Illinois Tollway Base Sheet Revisions
--

Section M		Base Sheet Drawings	
Drawing	Modification Summary	Effective: 03-01-2024	
Roadway Weather Information System (ITS)-Series 1300			
M-ITS-1300	RWIS Pole, Sensor Mounting Detail

TYPICAL RWIS SITE INSTALLATION PLAN

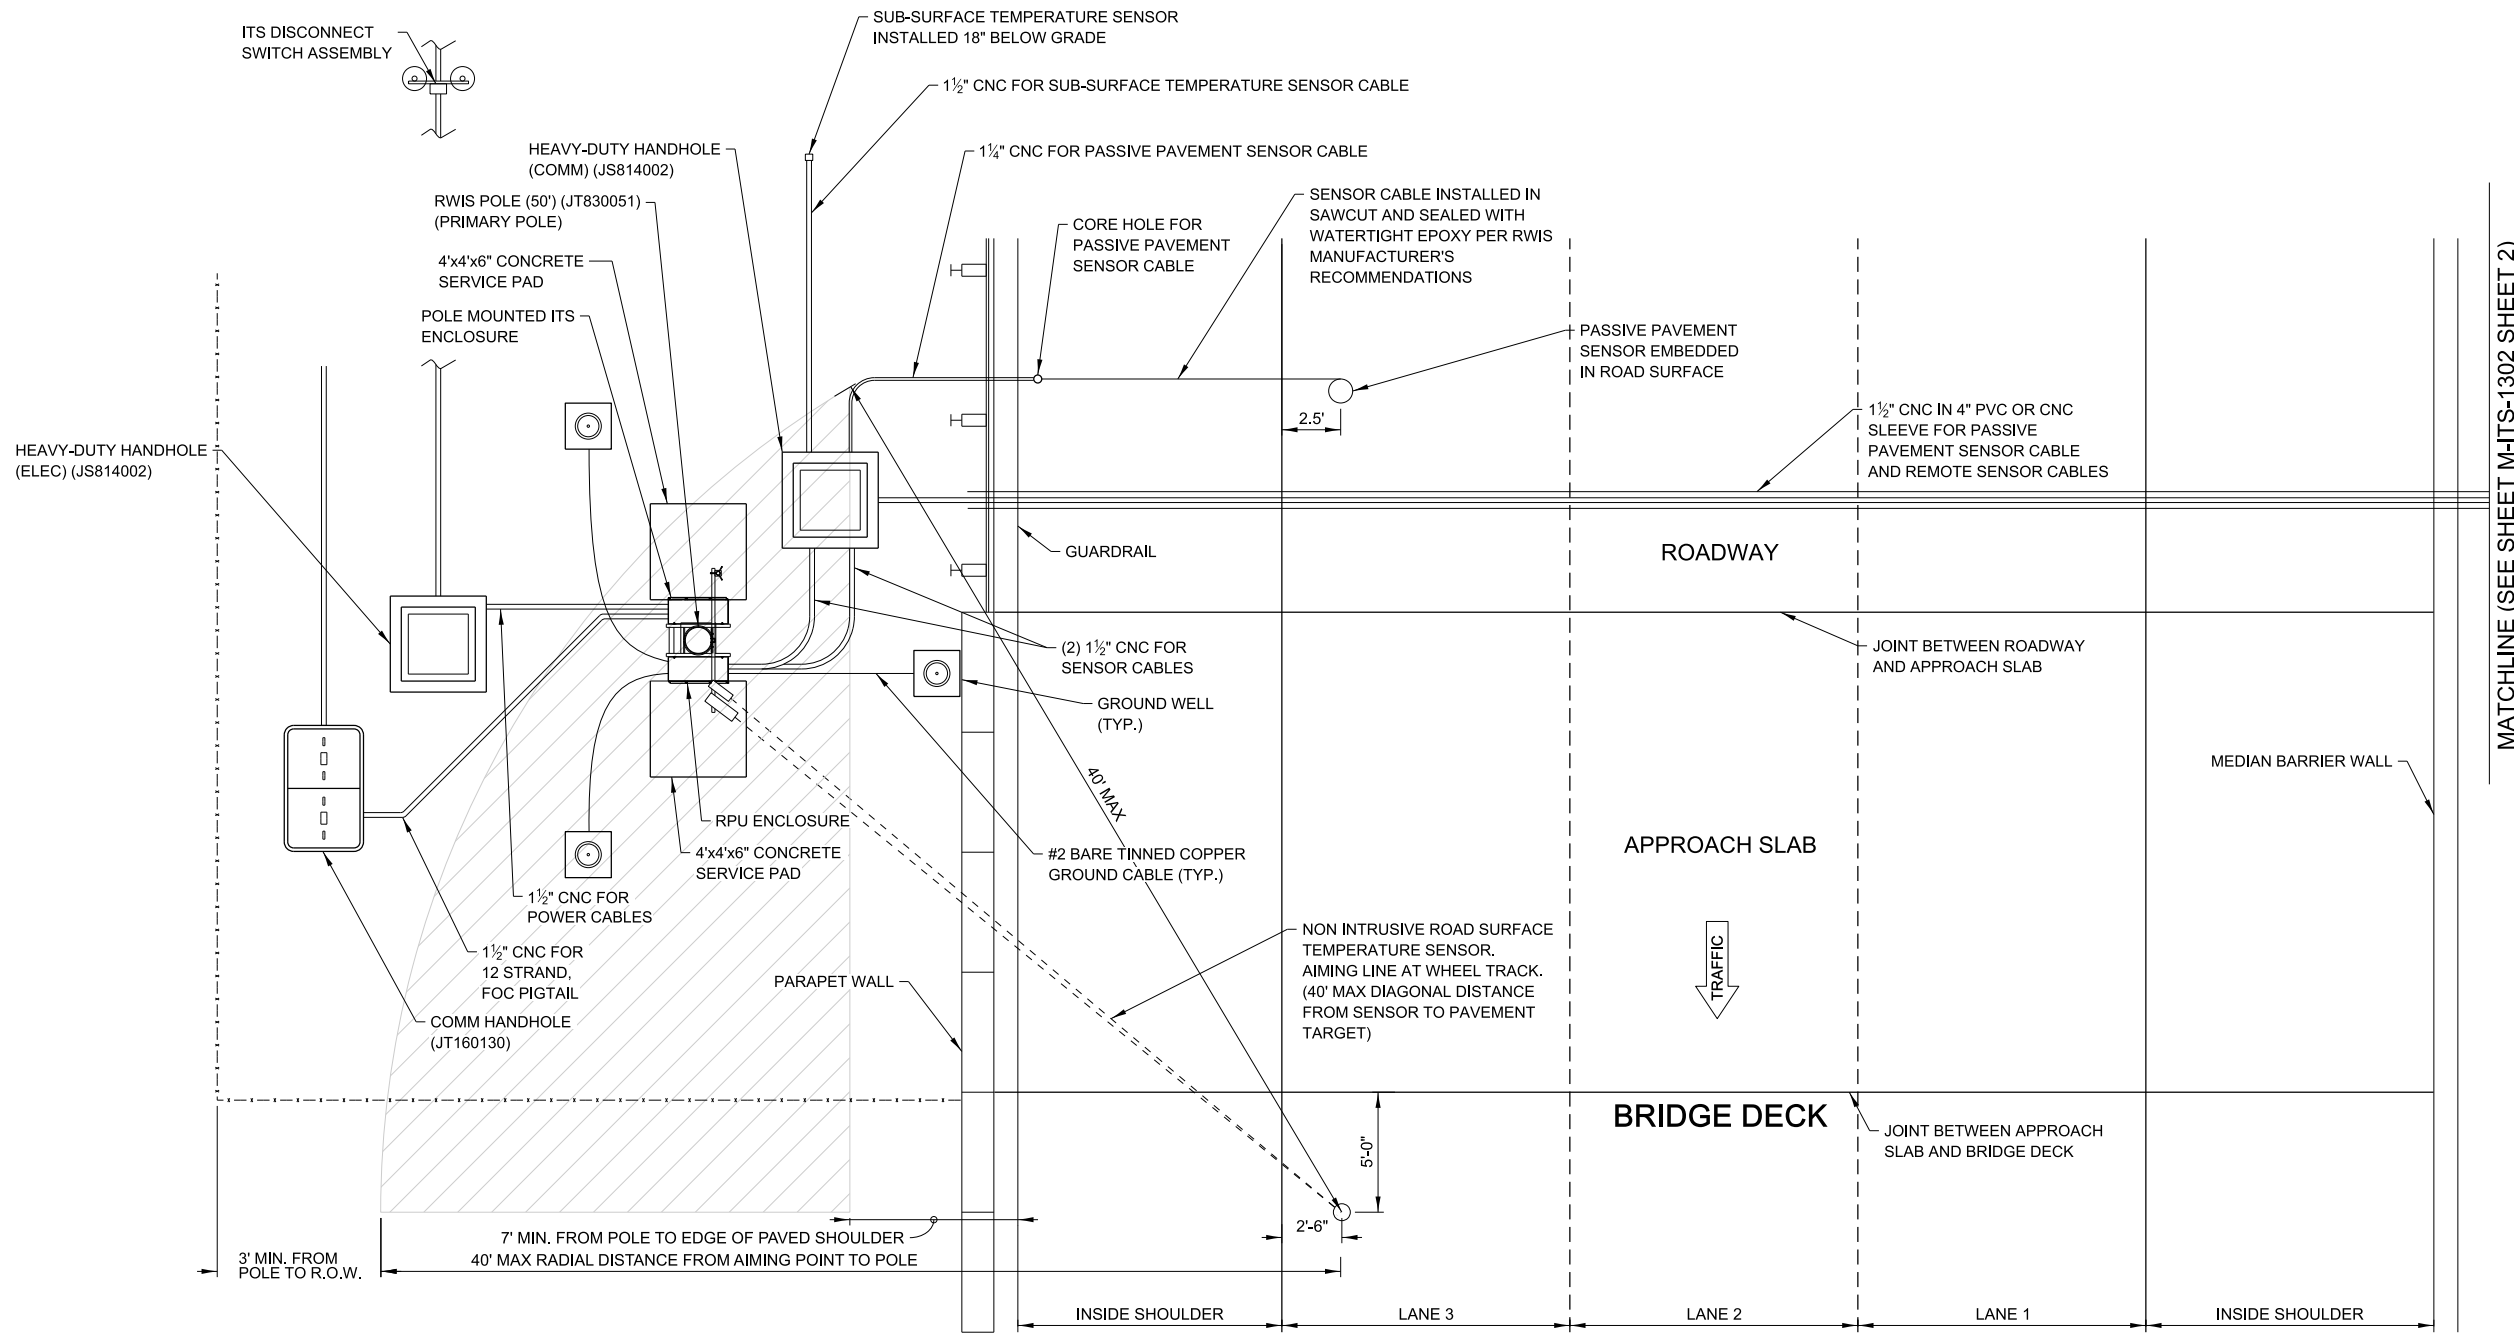
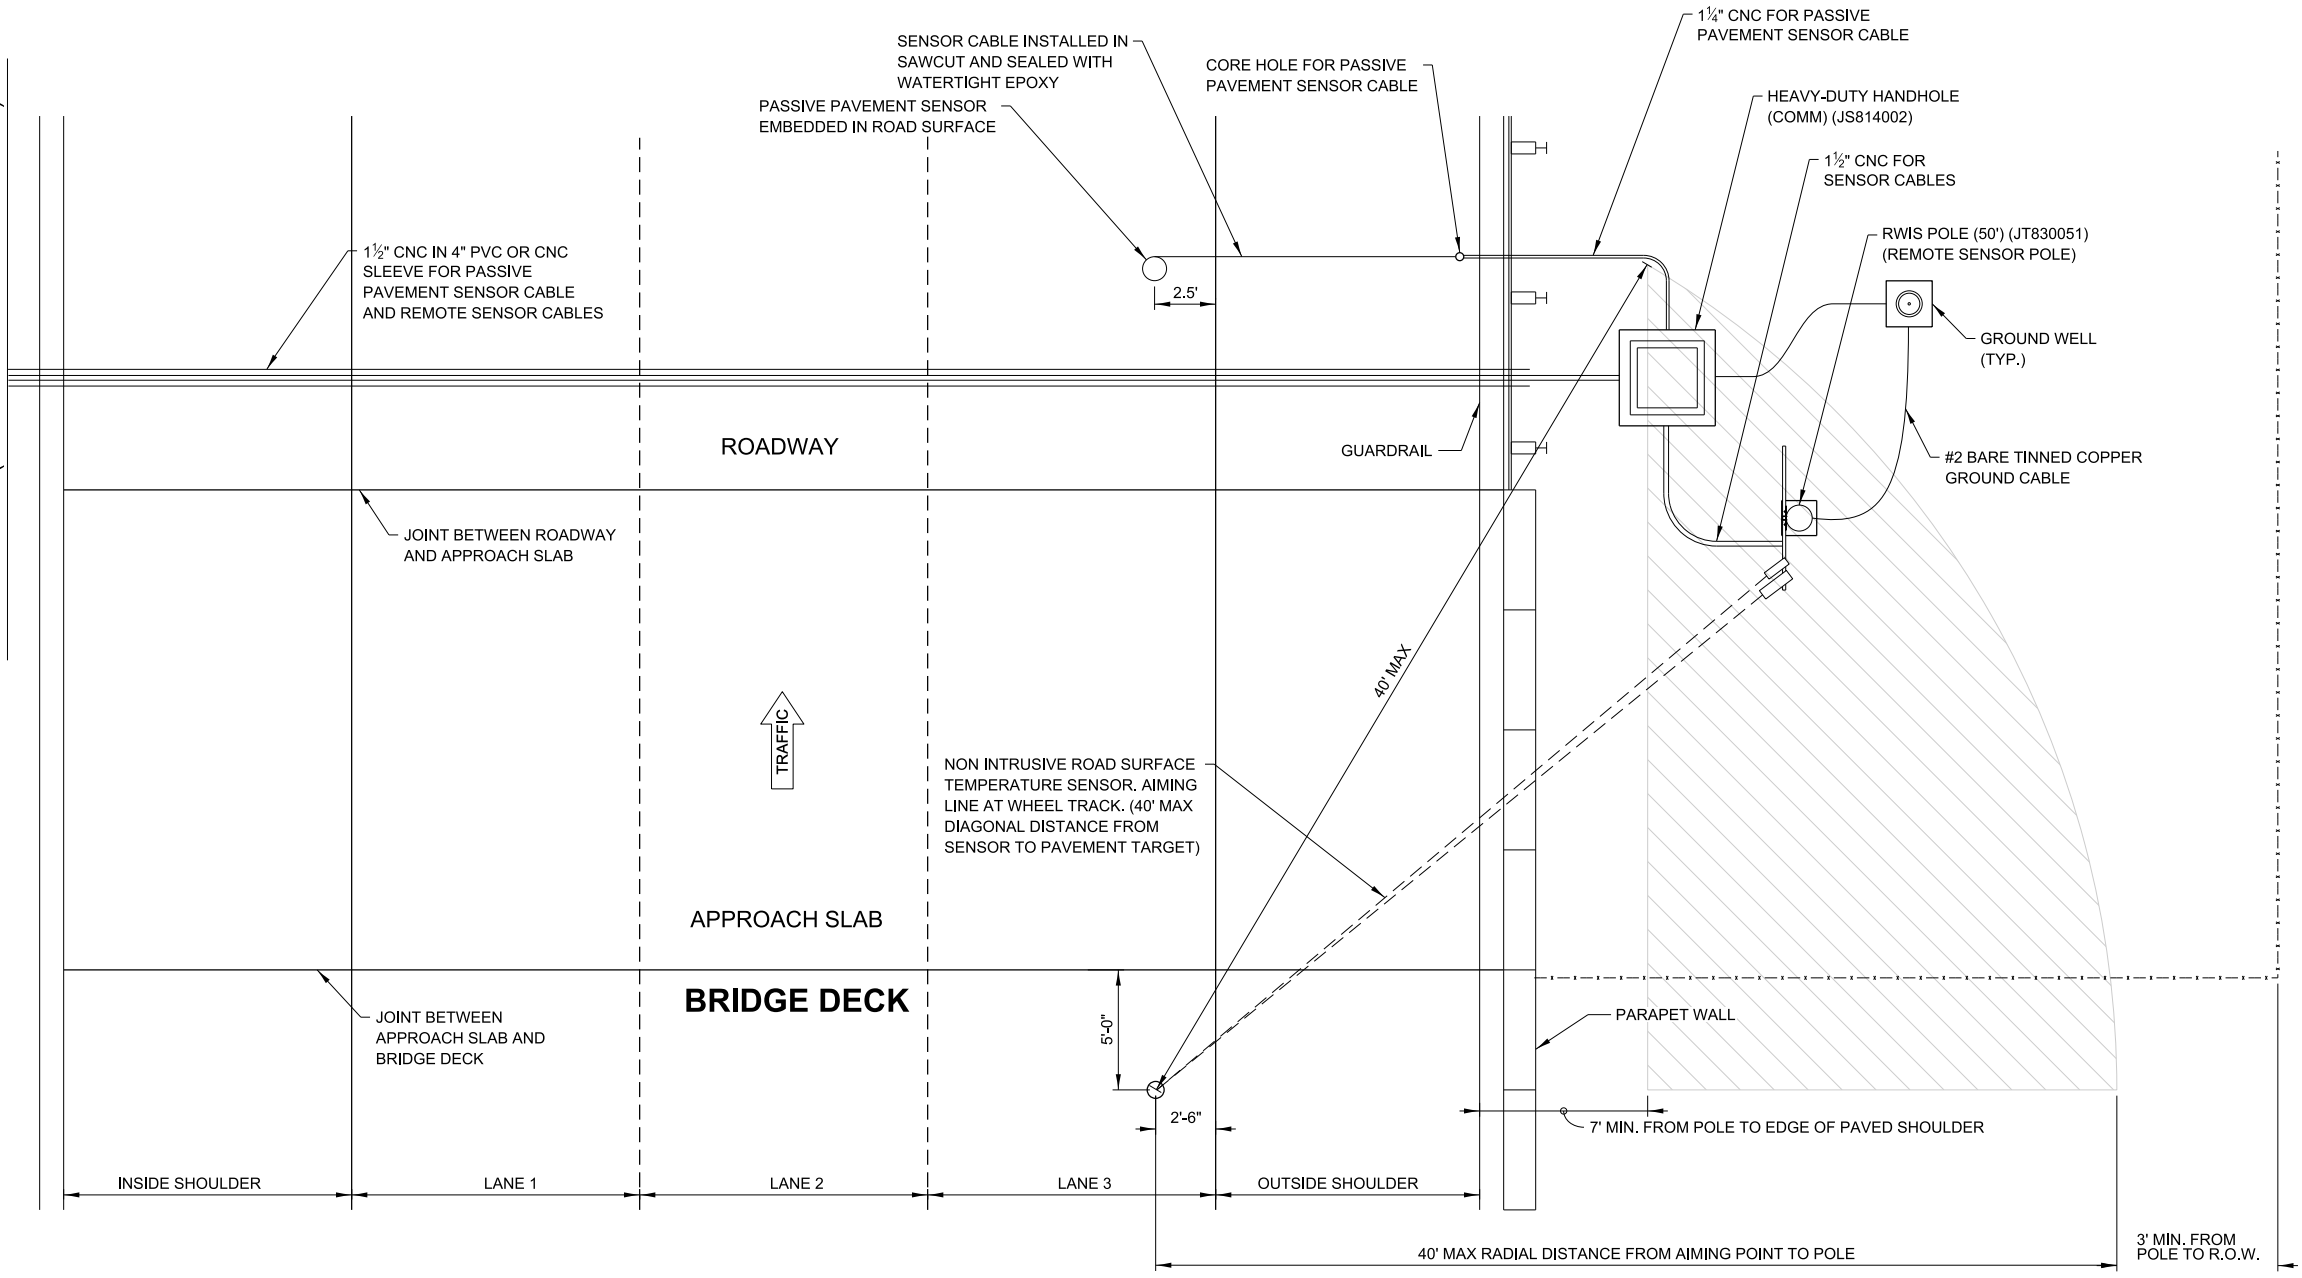
Sheet 1	Added a shade area where the RWIS Primary pole shall be installed and added dimensions to define the criteria where the RWIS pole should be installed. This to limit the non intrusive temperature sensor to meet the maximum 50 feet line of sight to the surface of the pavement.

USE TO ENSURE THE RWIS POLE IS LOCATED WITHIN SENSORS MAXIMUM DISTANCE (HATCHED AREA).

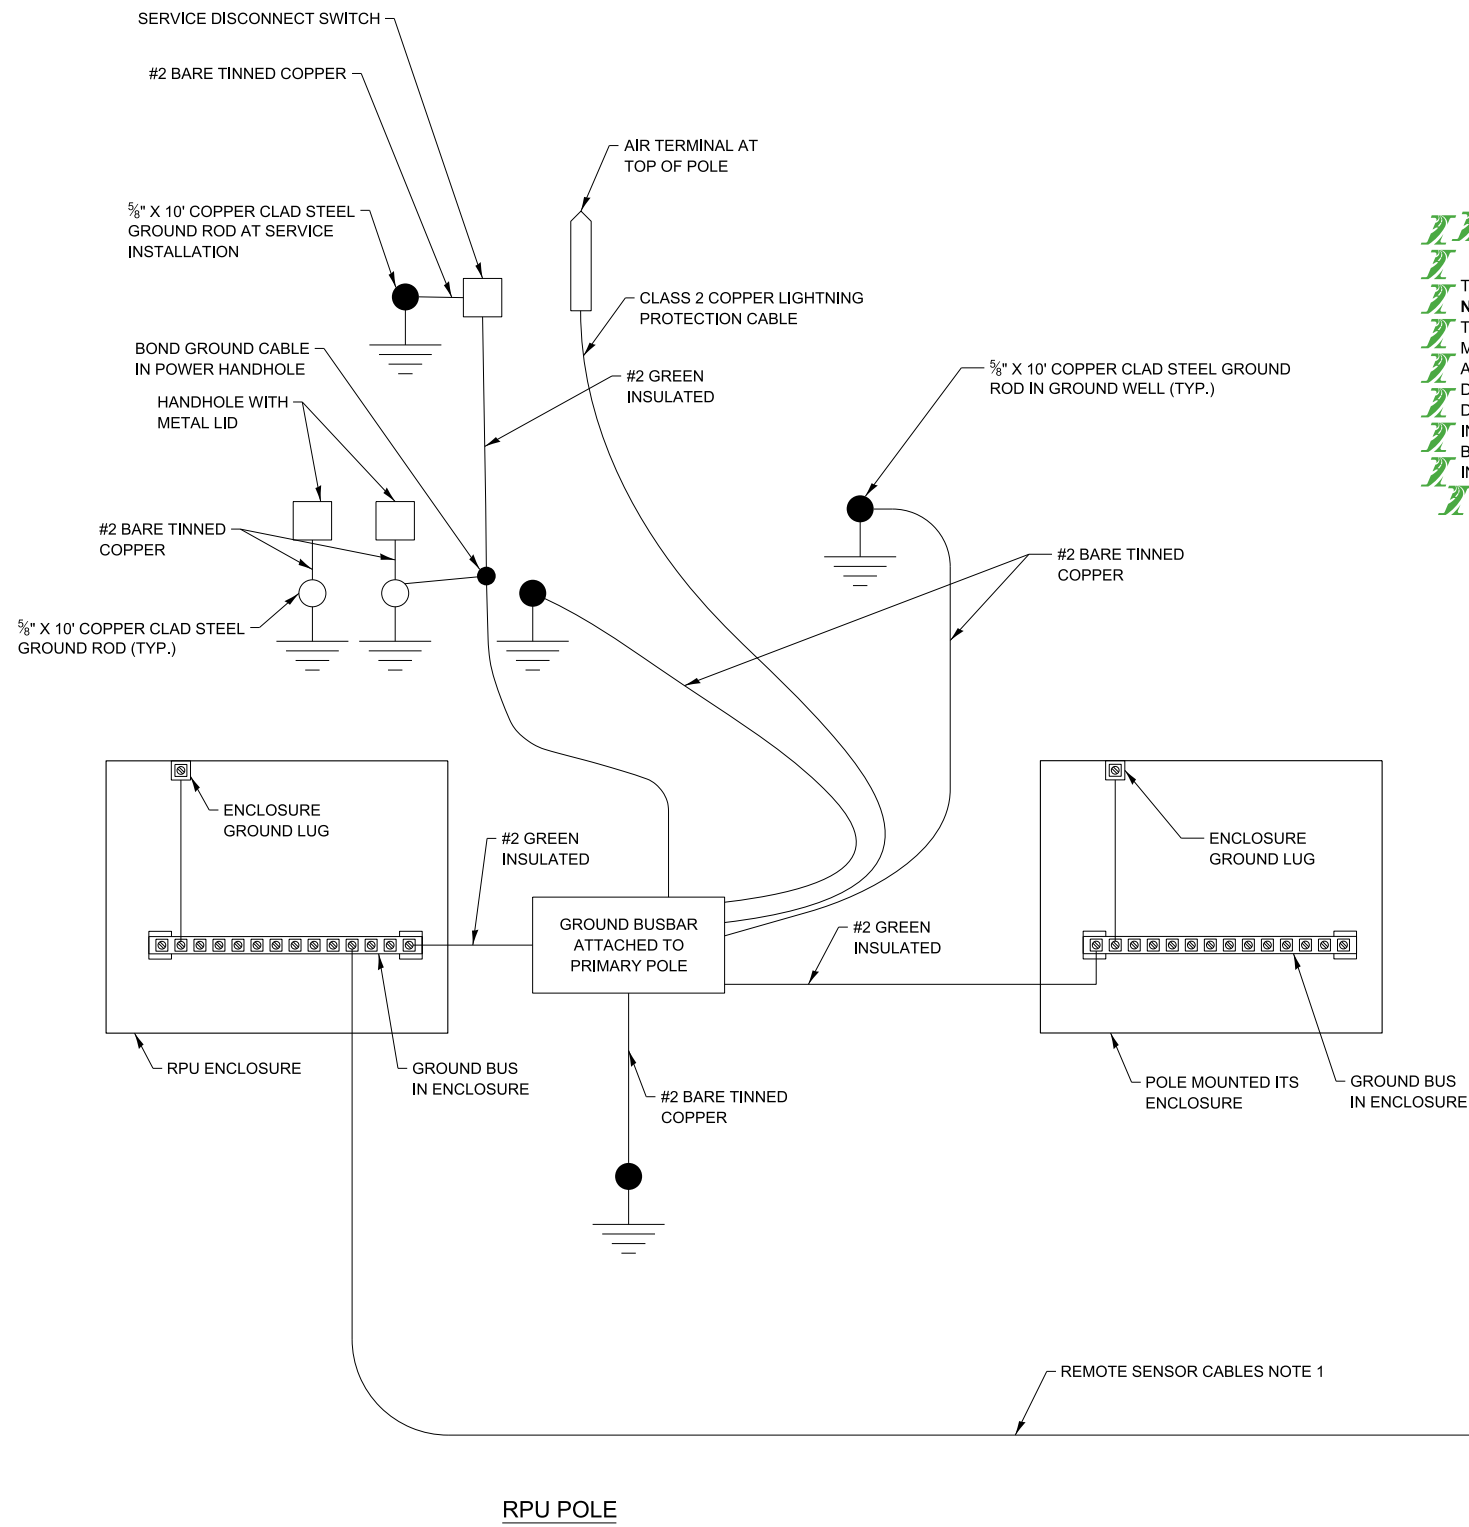
Sheet 2	Added a shade area where the RWIS Secondary pole shall be installed and added dimensions to define the criteria where the RWIS pole should be installed. This to limit the non intrusive temperature sensor to meet the maximum 50 feet line of sight to the surface of the pavement.

NOTE 4 TO DESIGNER
 DSE TO ENSURE THE RWIS POLE IS LOCATED WITHIN SENSORS MAXIMUM DISTANCE (HATCHED AREA).
